1015 W UNIVERSITY AVE.
(TESLA STATION)
GEORGETOWN, TX 78628

TITLE SHEET &
PROJECT DATA

Sec 1.11
"Project 2020-1-SDP", display on each
sheet in the bottom right hand corner.

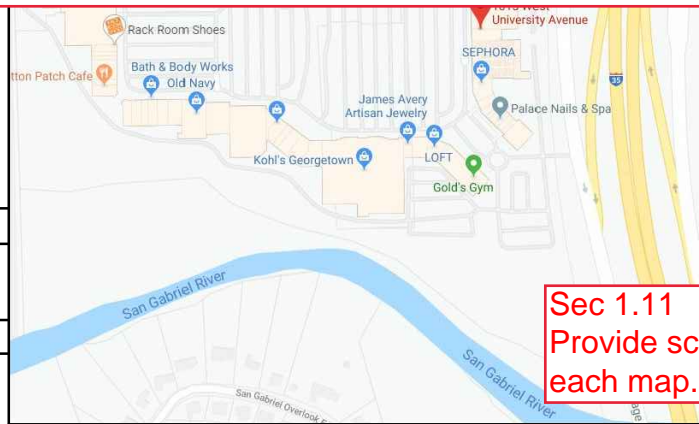
Addressing:
1013 W UNIVERSITY AVE UNIT 99,
Revise.

Electric:
At this time, the City of Georgetown will not allow retail sale of electric power in the city limits of Georgetown. Please contact the Electric Department or the Planning Department to discuss this matter.

Revise Legal Description:
Wolf Ranch Block A
Lot 2 Resubdivision

Sec 1.11 In Title Block:
Display Original Date and any Revision Dates

Sec 1.11. Following is required on the Cover Sheet.

Sec 1.11 Display:
Proposed Use
Proposed Impervious Coverage (or existing)
Final Plat Case Number

Sec 1.11
Provide scale and north arrow for each map.

DEMOLITION PLAN

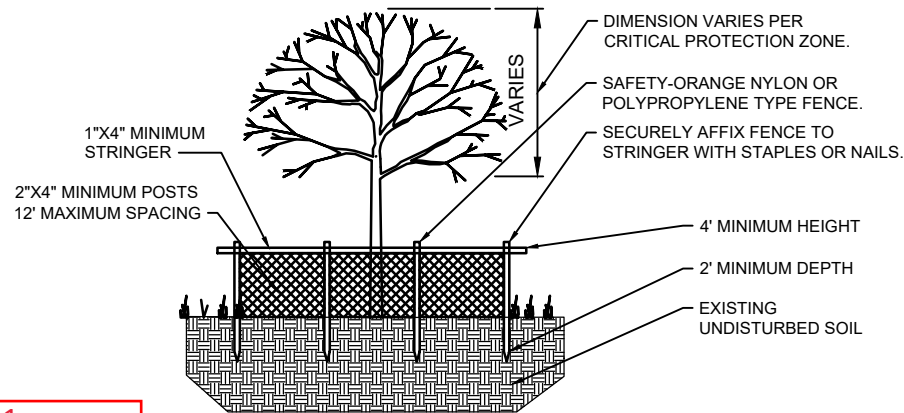
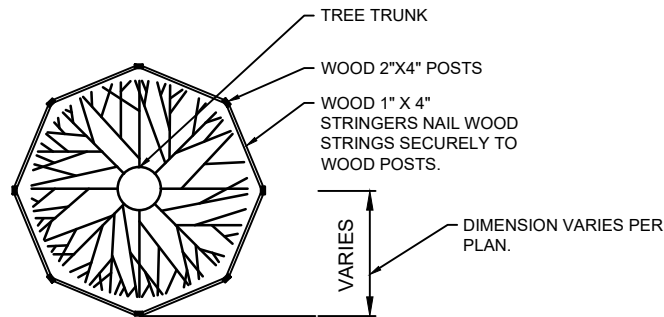
Per Sec 1.11
- Show existing trees
in this area on all
sheets where
landscape is shown

SHEET TITLE
SITE PLAN

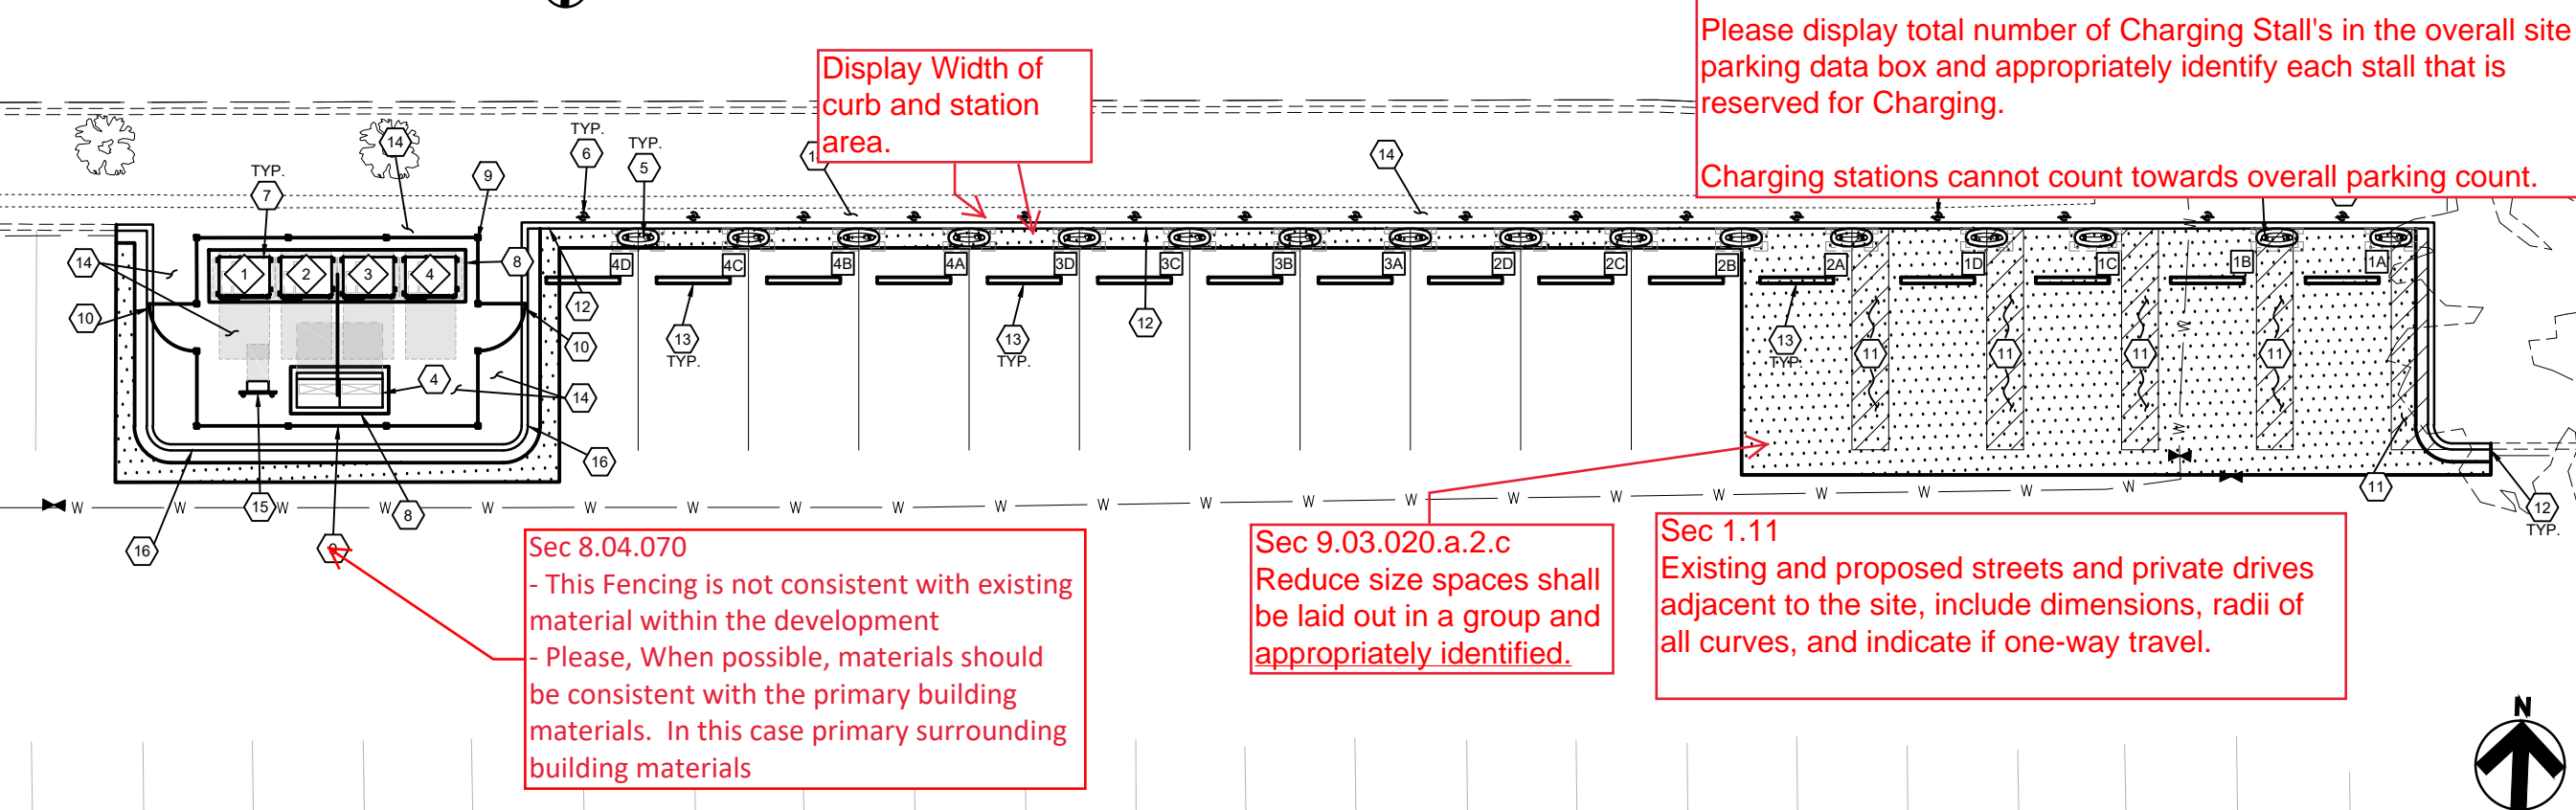
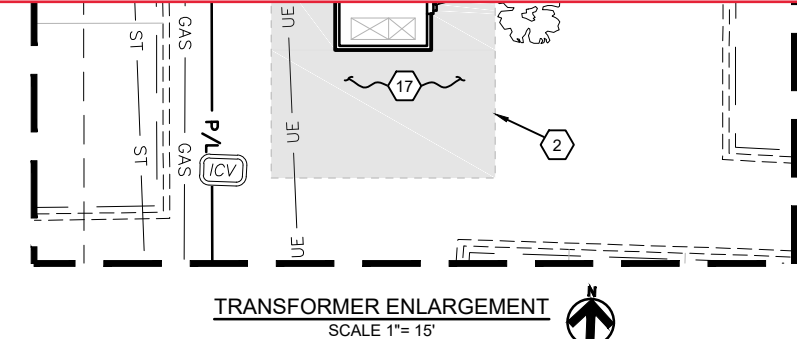
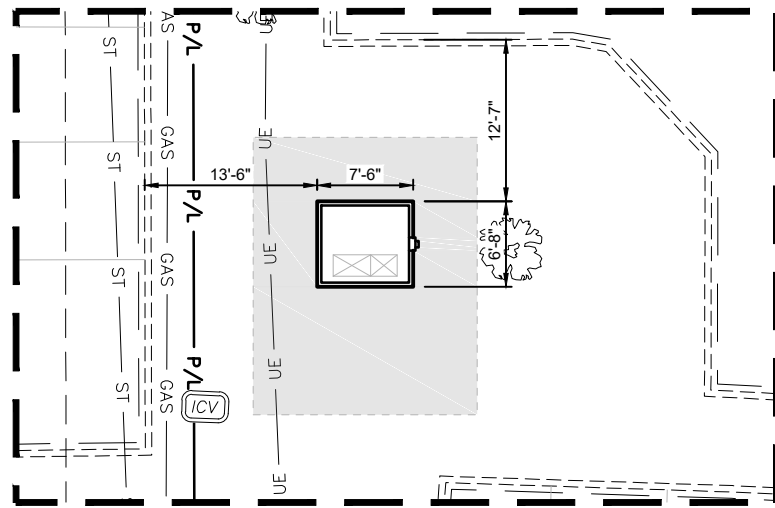
Sec 1.11 Required Site Plan Notes

Please display total number of Charging Stall's in the overall site parking data box and appropriately identify each stall that is reserved for Charging.

Charging stations cannot count towards overall parking count.

EQUIPMENT DIMENSION PLAN

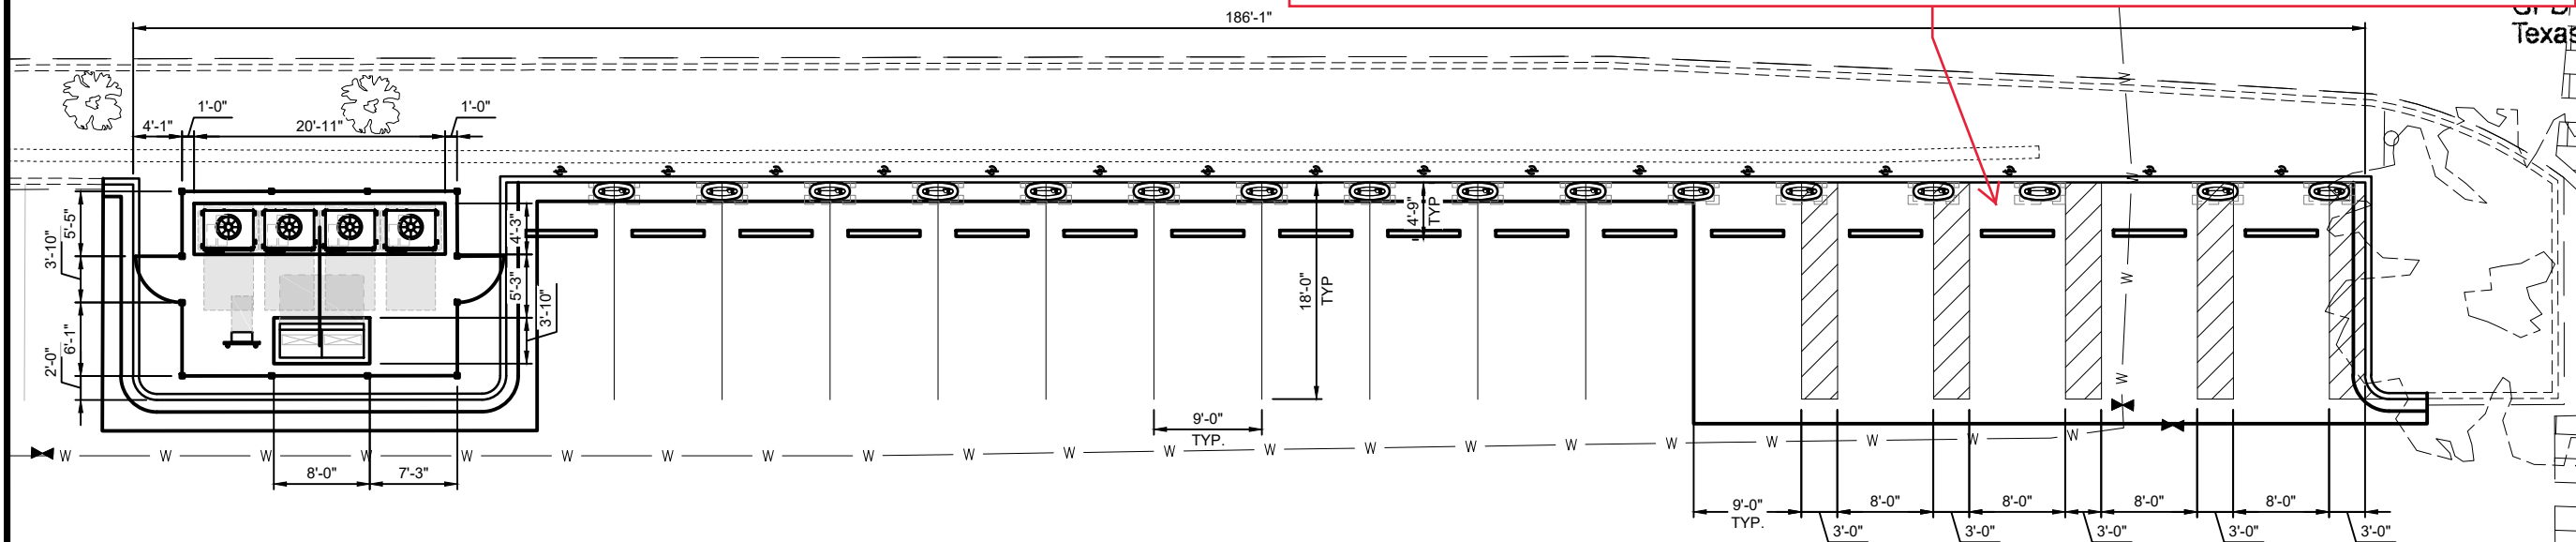
Sec 1.11
Display square footage of each transformer.

Sec 9.03.020.a.1 Parking space min size: 9' x 18'.
Sec 9.03.020.a.2.c Reduce size spaces shall be laid out in a group and appropriately identified.
